Tower Site Construction – Phase 3 D-F

Grant County, Wisconsin

Addendum #01

SHEET NUMBER: **T-201**

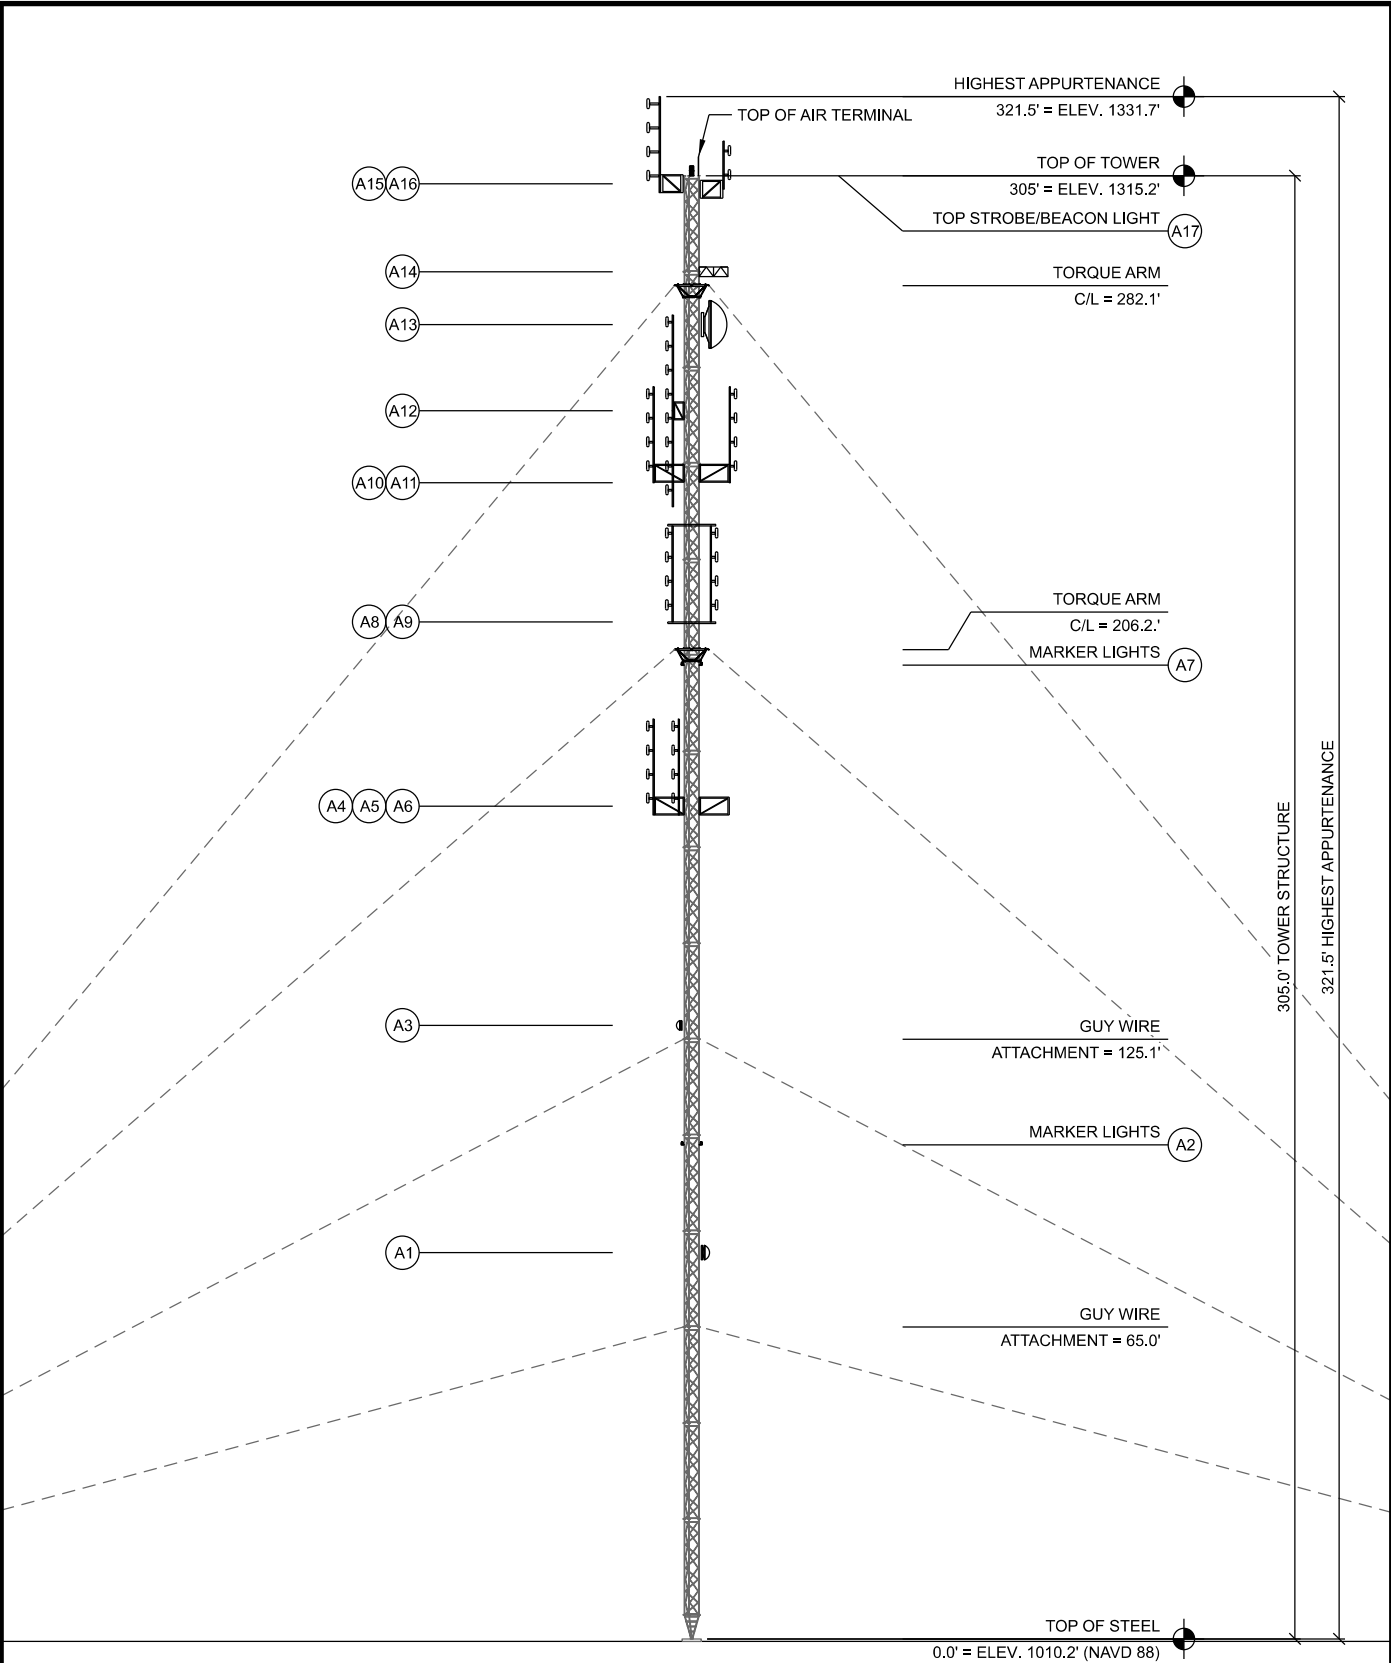
1. *What is the antenna loading of the existing tower at the South GF3 site? What items will be salvaged?*

Answer: We have included the existing tower inventory and photo of the existing tower to this addendum. No existing antennas or dishes will be salvaged.
